**PLANNING APPROVAL &
SUBDIVISION STAFF REPORT****Date: May 19, 2011****NAME**

Plantation Memorial Gardens Subdivision

LOCATION5501 Bear Fork Road
(South side of Bear Fork Road at the South terminus of
Jarrett Road)**CITY COUNCIL
DISTRICT**

AREA OF PROPERTY1 lot / 25.0 acres \pm **CONTEMPLATED USE**Planning Approval to allow a cemetery with 21,250 plots in
an R-1, Single-Family Residential District, and Subdivision
approval to create one lot.**TIME SCHEDULE
FOR DEVELOPMENT**Phase One, one year
Phase Two, the remainder of parcel, within seven years**ENGINEERING
COMMENTS**

SITE PLAN

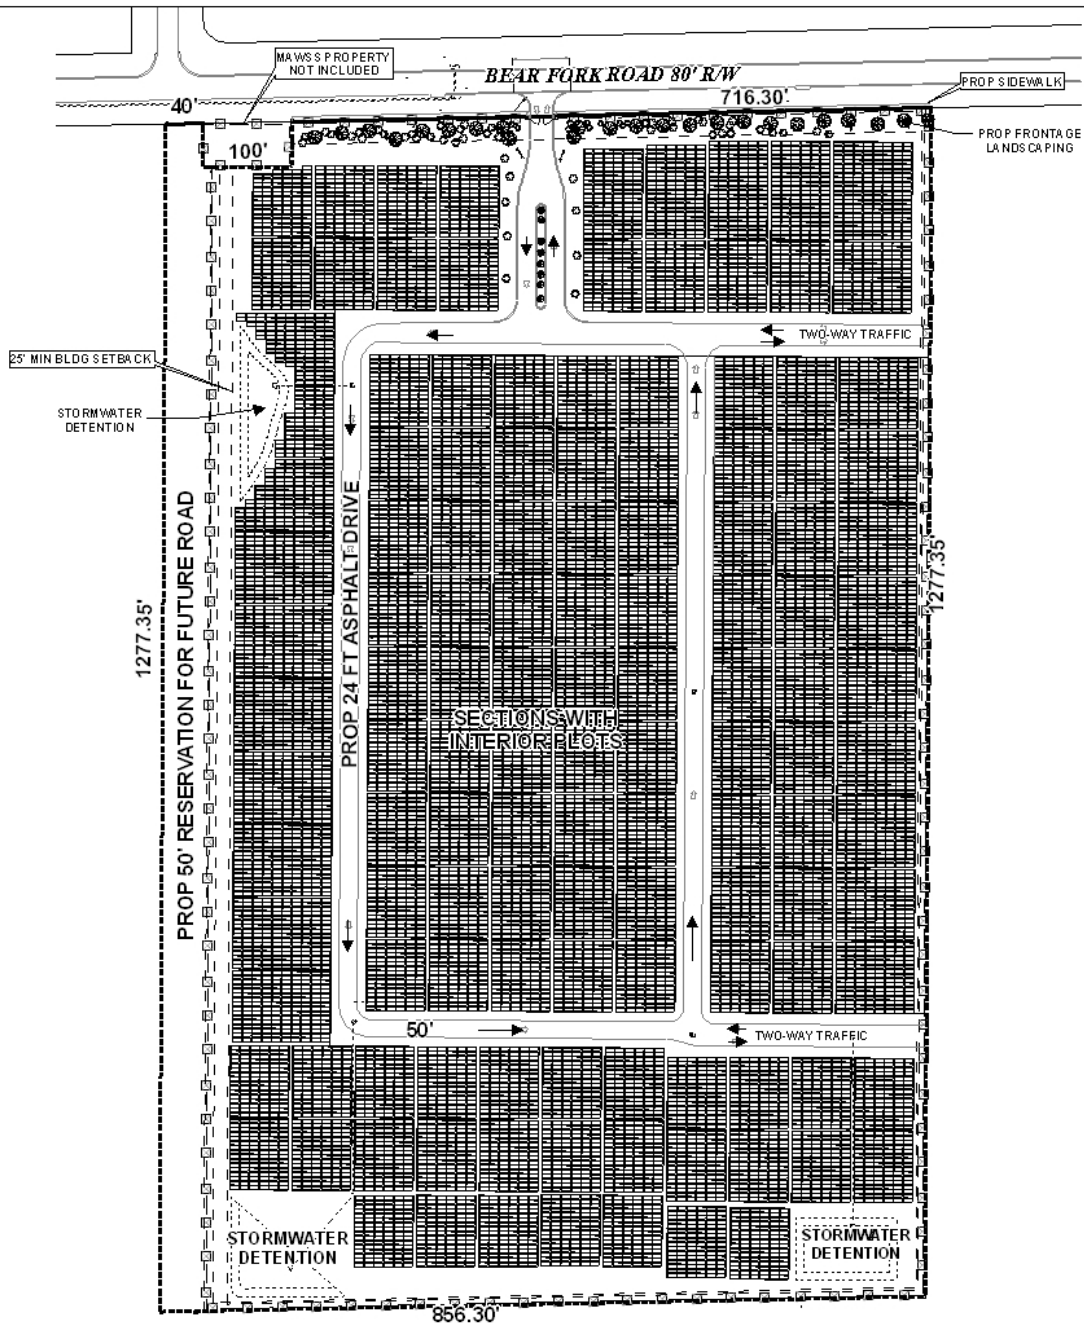
Must comply with all storm water and flood control ordinances. Any increase in impervious area in excess of 4,000 square feet will require detention. The proposed detention pond will need to be sized to provide at a minimum, detention from a 100 year storm with a 2 year release rate as outlined in the storm water ordinance. Any work performed in the right of way will require a right of way permit in addition to any required land disturbance permit.

COMMENTS Driveway number, size, location, and design to be approved by Traffic Engineering and conform to AASHTO standards. Driveway shown is 60 feet in width. Narrow the driveway to a standard width of 24 feet

While Bear Fork Road is a minor street, access management is a concern. The site plan depicts one curb-cut onto Bear Fork Road, although the proposed lot has nearly 900 feet of frontage onto Bear Fork Road. To ensure consistency with the submitted site plan, the proposed lot should be limited to one curb-cut to Bear Fork Road, with the size, design and location to be approved by Traffic Engineering and Planning, and to comply with AASHTO standards.

As a commercial development, full compliance with the tree and landscaping requirements of the Zoning Ordinance will be required. The site plan depicts fairly extensive landscaping along Bear Fork Road, however, no landscape or tree calculations are provided. As the majority of the cemetery will be sod, landscape area should not be an issue. Due to the extensive frontage and perimeter, however, the provision of an adequate number of frontage and perimeter trees is questionable, thus the site plan should be revised to indicate the provision of required trees, or existing trees that will be retained for credit.

Due to the proposed use of the site as a cemetery, buffering should be provided. A minimum of a 10-foot wide landscape buffer should be provided where the site abuts R-1 property, and due to the size of the property, this buffer can remain as a natural vegetative buffer. If the applicant intends to place a fence and gates on the site, the site plan should indicate the location of the fence and gates, as well as the proposed height.

Finally, the 25-foot minimum building setback line is not depicted on the plat, however it is partially depicted on the site plan. The plat and site plan should be revised to depict the 25-foot minimum building setback line along both Bear Fork Road and the proposed Middle Ring Road right-of-way.

The preliminary Subdivision plat does not appear to reflect the required setbacks from Bear Fork Road and the setback in-lieu of dedication for the proposed Middle Ring Road, and the

required 25-foot setback. These setbacks are depicted on the Planning Approval site plan. The preliminary plat should be revised to show all setbacks. The “50’ reservation for future road” label should be removed, and instead be relabeled as a “50’ setback in-lieu of dedication for future road” for both the site plan and plat.

A 3-foot high decorative fence with gate is proposed along the Bear Fork Road frontage. The gate, as proposed, will be almost on the right-of-way edge, however, typically a distance of three (3) queuing spaces, or 51-feet, is required between a gate and the edge of the right-of-way, thus the site plan should be revised to reflect this requirement. In addition to the decorative fence, a 6-foot high chain link fence is proposed around the remainder of the site. Permits will be required for the proposed fencing.

Internal circulation has been changed to provide two stubs to the East of the site, anticipating future expansion of the cemetery. A one-way loop will serve the majority of the site: one way drives should be marked with signage and pavement markings.

Frontage trees are depicted along Bear Fork Road, while natural buffers, 10-feet wide, are depicted along the West, South and East sides. Even though frontage trees and natural buffers are depicted, compliance with the tree and landscaping requirements of the Zoning Ordinance cannot be determined. The applicant must ensure that the site will meet all tree and landscaping requirements, including frontage and perimeter trees, as well as landscape area: a revised site plan depicting compliance should be submitted prior to any request for land disturbance.

- 1) First phase of development limited to a maximum of 21,250 plots;
- 2) Revision of the site plan to depict compliance with the tree and landscaping requirements of the Zoning Ordinance, including calculations for open space and trees;

- 3) Revision of the site plan to depict a 51-foot setback for the proposed entry gate from the Bear Fork Road right-of-way;
- 4) Revision of the label for Middle Ring Road to depict the future right-of-way as a “50’ setback in-lieu of dedication for future road;”

- 5) Obtaining of permits for any proposed fencing;
- 6) Depiction of one-way pavement markings and signs for those portions of the driveways that will be one-way;

- 7) Compliance with Traffic Engineering comments (*Driveway number, size, location, and design to be approved by Traffic Engineering and conform to AASHTO standards. Driveway shown is 60 feet in width. Narrow the driveway to a standard width of 24 feet;*)

- 8) Compliance with Engineering comments (*Must comply with all storm water and flood control ordinances. Any increase in impervious area in excess of 4,000 square feet will require detention. The proposed detention pond will need to be sized to provide at a minimum, detention from a 100 year storm with a 2 year release rate as outlined in the storm water ordinance. Any work performed in the right of way will require a right of way permit in addition to any required land disturbance permit*); and
- 9) Submission of a revised site plan prior to completion of the Subdivision process or any request for land disturbance.
